Planning & Zoning Commission Meeting - Special AGENDA

STAFF REPORT KETCHUM PLANNING AND ZONING COMMISSION SPECIAL MEETING OF JUNE 22, 2020

PROJECT: 3020 Warm Springs Rd Duplex Design Review

FILE NUMBER: P20-031

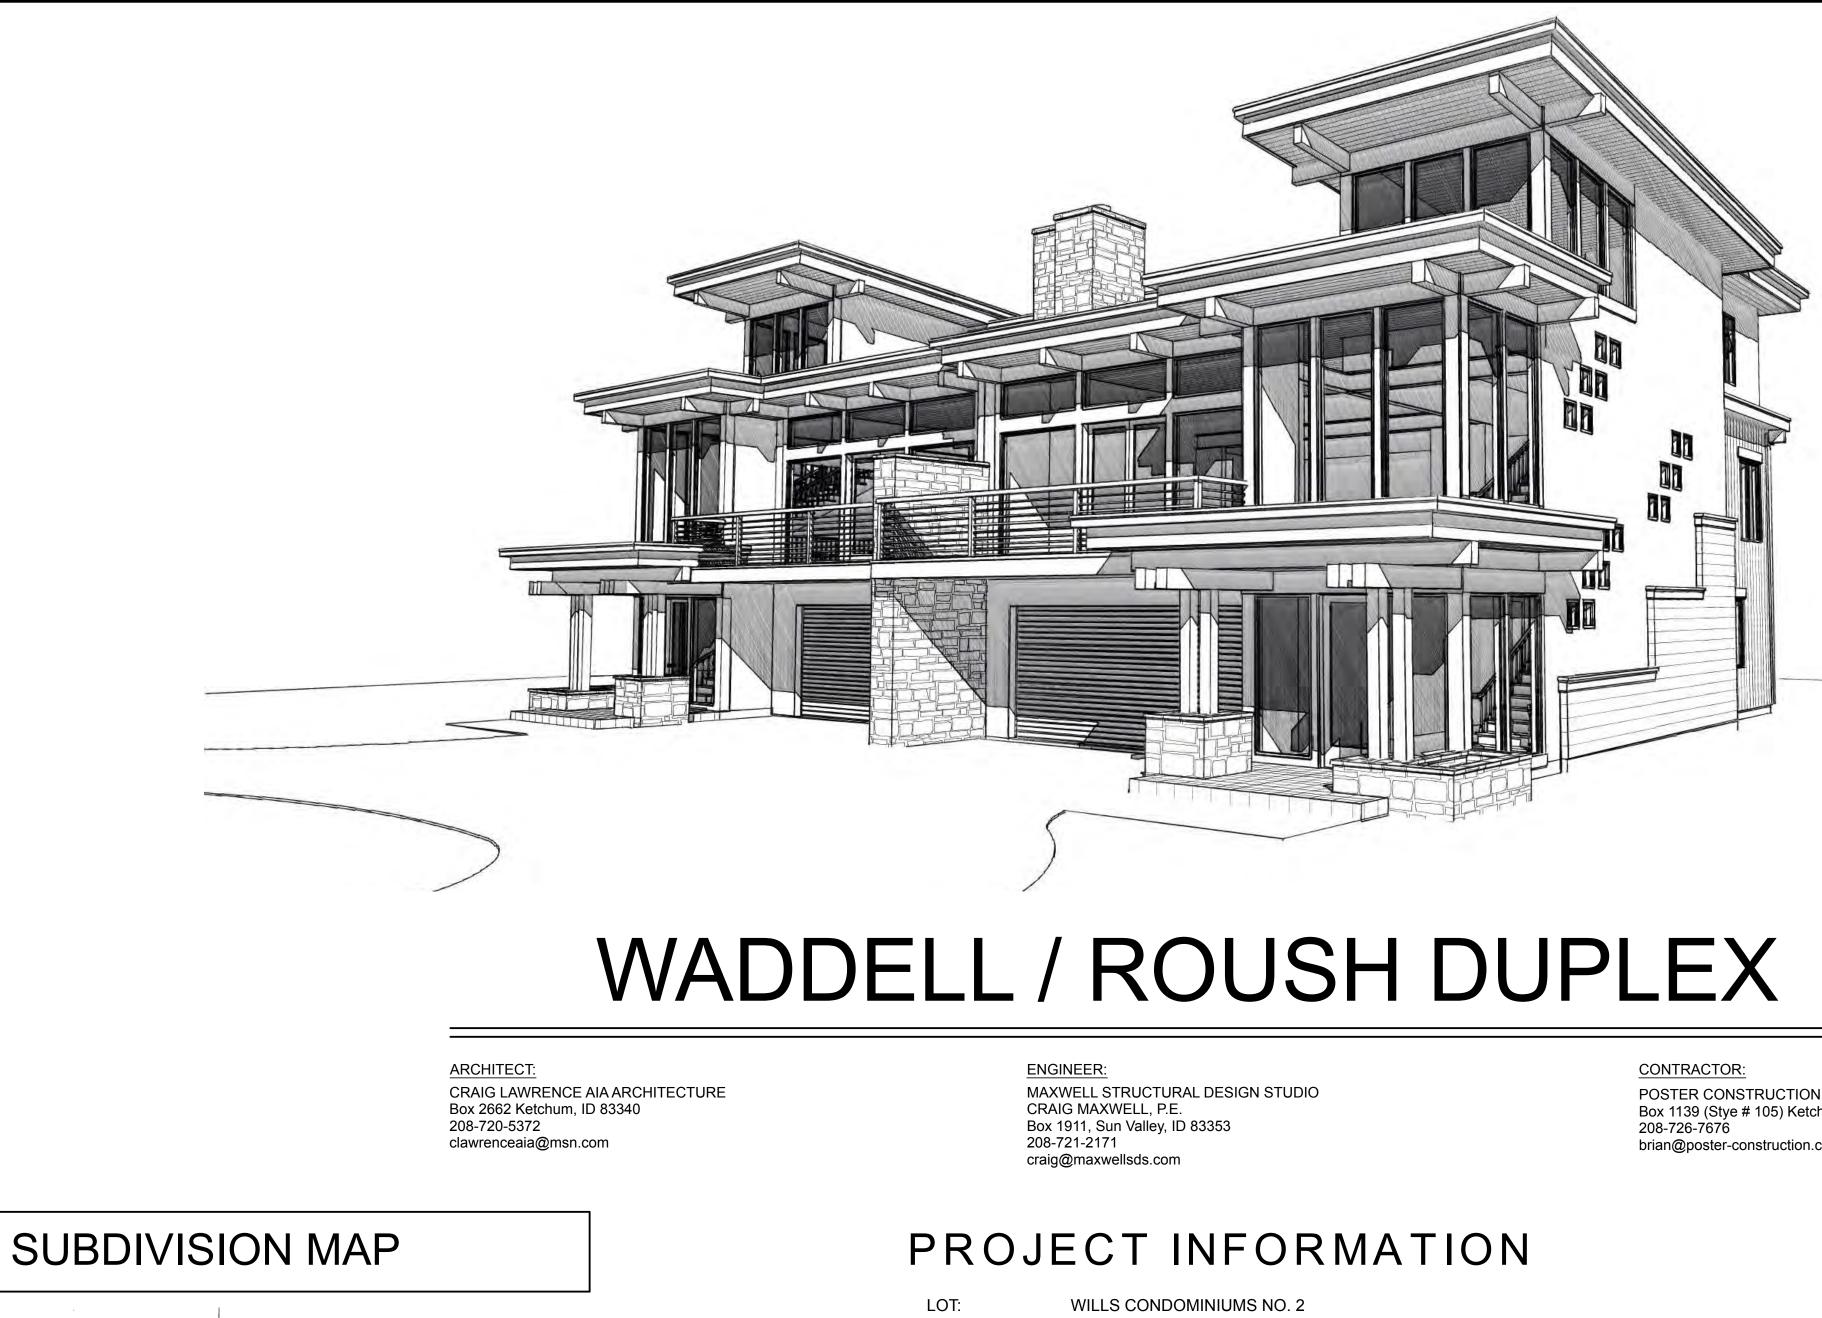
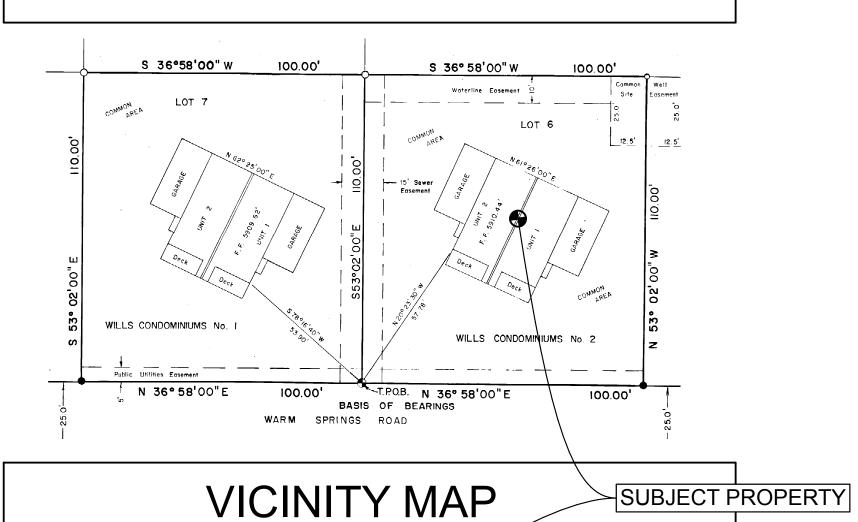
- 1. The biggest and most dramatic change is the Upper Level of the North/back wall of the Duplex has been moved in 18" from its previous location. The owners have agreed to the square footage reductions and the additional cost this change will require at the Upper Level:

- The Bedroom and Bathroom sizes have been reduced to facilitate this.
 - The wall below remains in the same place. The revised wall location and necessary additional roof at the Main Level create a strong <u>datum</u> <u>that highlights the horizontal undulation of the rear façade</u>.

- The Upper Level roof overhang is now back 18" from its previous position.
 - The cedar siding has been revised to accommodate the changes and make for a pleasing and varied Elevation.

- Cosmetic Headers were added to the windows in the cedar siding portion of these facades to add visual interest.
- 2. I continue to feel that the project has been well within the code requirements of the Design Review Evaluation Standards (17.96.060) of the Ketchum Code. We have made these <u>aggressive</u> changes in hopes of making a more pleasing façade, which will be screened by trees, but still visible to the neighbors to the North. I feel we are now <u>well beyond</u> what is required by the Ketchum Code.

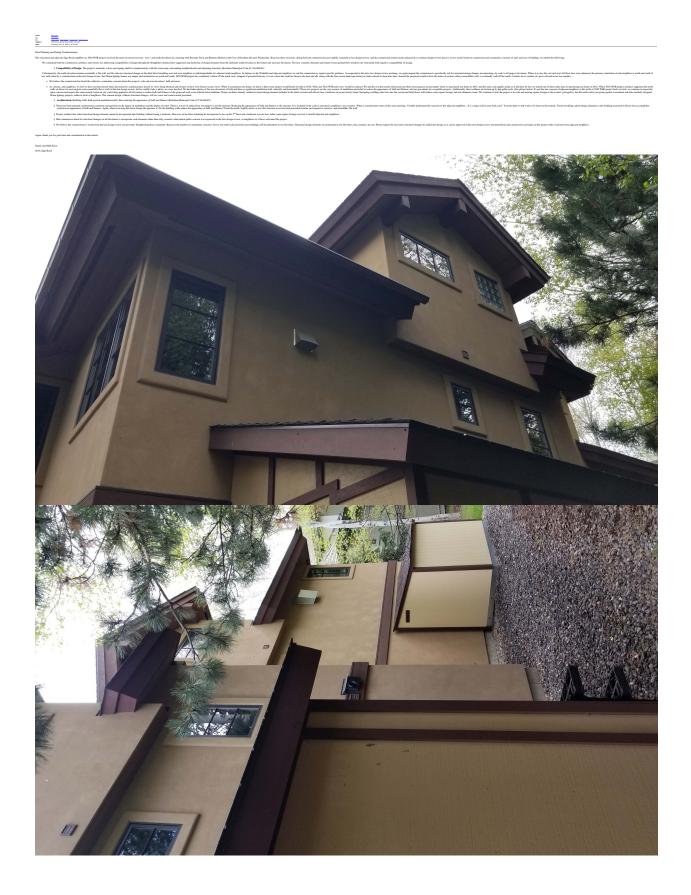
- Unfortunately, the north elevation remains essentially a flat wall, and the side tier structural change on the third floor benefiting east and west neighbors is indistinguishable for adjacent north neighbors. In fairness to the Waddells and adjacent neighbors we ask the commission to request specific guidance. As requested in the prior two design review meetings, we again request the commission to specifically ask for structural design changes incorporating city code to all project elevations. Where it is nice the east and west 3rd floor tiers were enhanced, the primary orientation of side neighbors is north and south. It was well stated by a commissioner in the last design review, that Warm Springs homes are unique and orientations are north and south. 3020 WSR project has completely written off the north view, stripped of potential balcony or even a door that could tie them to the deer and elk, along with the four season landscape beauty in stark contrast to deep blue skies. Instead the proposed conifers show the intent of owners soften a monolithic wall, to eventually wall off the north. Conifers do as conifers do, grow tall and never lose needles...

we continue to repeat the same concern and request the same remedy based on city code being applied to all elevations to reduce bulk and flatness of the proposed wall, even with the latest additions. Project architect already rendered a tiered design element included in the latest revision and did not lose a bedroom as he previously stated. Designing wedding cake tiers into the second and third floors will reduce some square footage, but not eliminate rooms. We continue to hear the project is in code and maxing square footage is the owners' prerogative, but the north wall is not going against a mountain side like similarly designed Warm Springs projects, rather in front of neighbors. This current design, without structural changes, will set a new and controversial precedent.

- § Architectural: Building walls shall provide undulation/relief, thus reducing the appearance of bulk and flatness (Ketchum Municipal Code §17.96.060.F5).

- § There has been repeated commissioner comment and question on the degree of undulation and the degree of relief. There is a level of subjectivity, but degree is not the measure. Reducing the appearance of bulk and flatness is the measure. It is included in the code as structural compliance, not cosmetic. When a commissioner states in the same meeting, "I totally understand the concerns of the adjacent neighbors...It is a large wall in your back yard." It seems there is still work to be done on the remedy. Tiered (wedding caked) design elements as the building increased in floors best accomplishes reduction in appearance of bulk and flatness. Again, when reviewing this latest design the question is: Do the building walls reduce the appearance of bulk and flatness? From the north, slightly askew or not, this structure as revised and presented remains and expansive, massive, and monolithic flat wall.

Attachment A – Revised Site Plan, sheet ASK-001, dated June 9, 2020

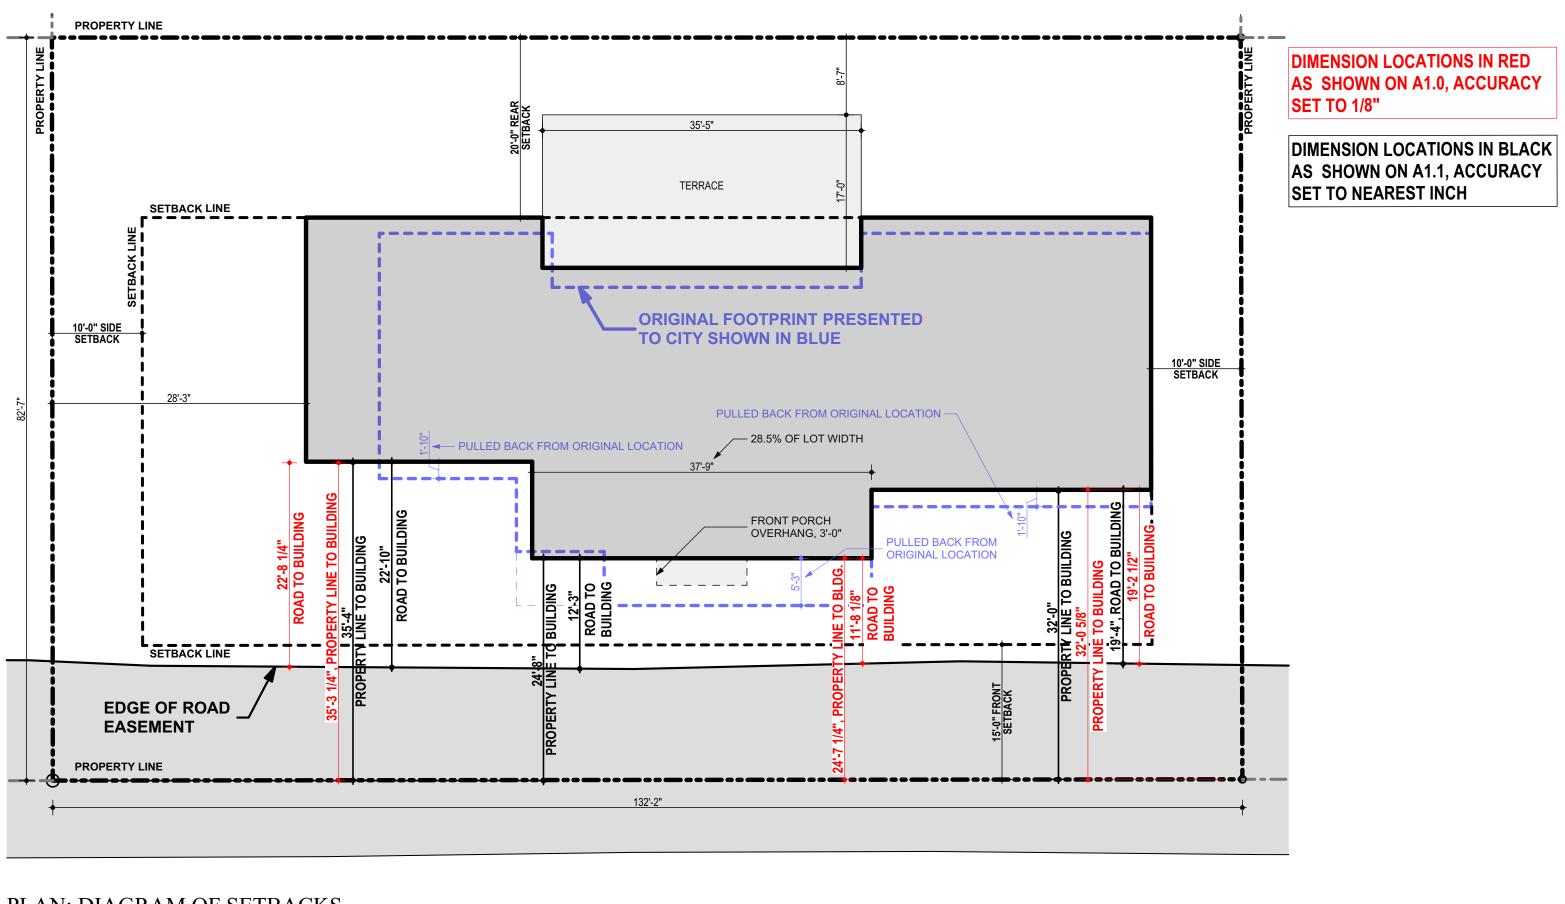
The March 6, 2020 plans show installation of a fence within 2'-7" of the edge of the roadway. The June 9, 2020 plans do not provide the same level of detail as the March 6th plans. If the fence is still proposed within 2'-7" of the edge of the pavement, based on the experience of the snowplow crews, this fence will impede snow removal operations.

• The setbacks as proposed by the applicant do not provide sufficient area to perform basic city services such as snow removal. This is a new development and all other new development projects constructed within Ketchum are designed and constructed to standards that do not impede or prevent basic city operations such as snow removal. Allowing this development to impede snow

- The City's standard residential lane width is 13' feet of asphalt or 26' in total for two lanes. Based on a standard lane width of 13' the City needs 14.9' of storage for snow. Looking at GIS and the site plan there is approximately a 13' section/swath of the paved portion of Garnet Street on the applicant's property which matches the City's standard lane width of 13' necessitating 14.9' for snow storage on the property due to the 13' of roadway.
